YEAR  
1991

MODEL  
LEGEND  
SEDAN

BULLETIN NO.  
91-024

## RECALL: Automatic Transmission Shift Cable

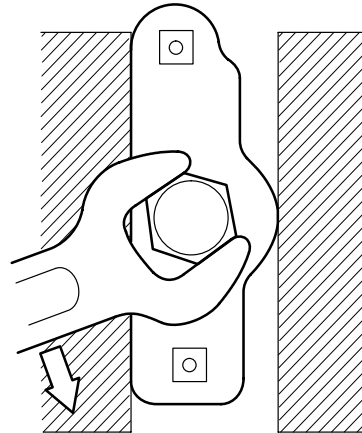
13. Clamp the cable/holder/base assembly in a vise. Loosen the locknut and remove the cable from the holder.

14. Install the new cable in the holder and tighten the locknut. Be careful to not deform the holder while tightening.
15. Insert the end of the cable into the floor tunnel hole. Install the shift cable bracket with two bolts.
16. Install the shift cable holder base on the transmission. Start the lower bolt first.
17. Install the shift control lever on the shaft with the original bolt. Use the new lock plate that came in the kit.
18. Install the shift cable cover. Reconnect the wire harness.

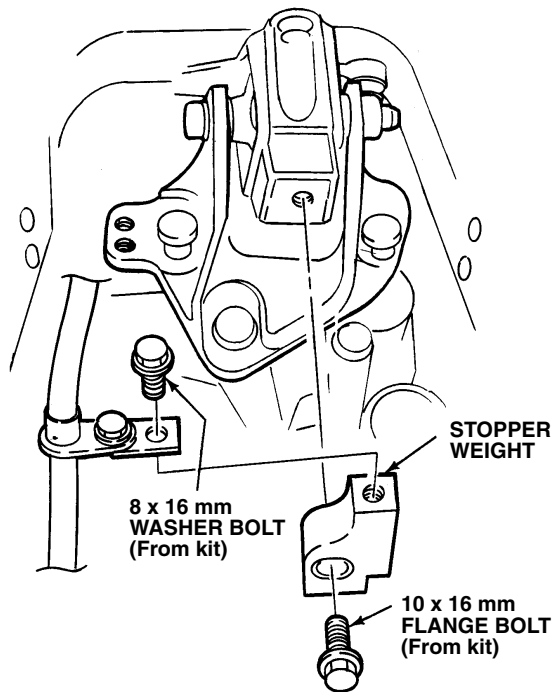
- Remove the transmission stopper weight. Install the new stopper weight with the 10x16 mm flange bolt from the kit.

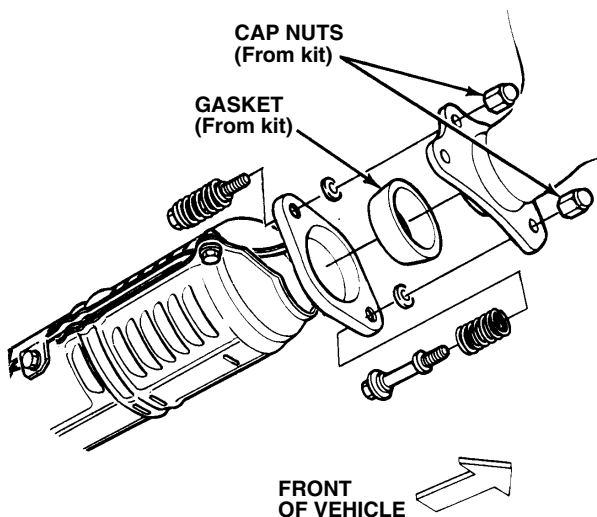
- Attach the shift cable guide to the stopper weight. Use the 8x16 mm washer bolt from the kit.
- Install the tunnel beam (four bolts).
- Reinstall the heat shield to the floor (seven bolts).
- Reconnect the catalytic converter to exhaust pipe A. Use the new exhaust gasket and cap nuts from the kit.
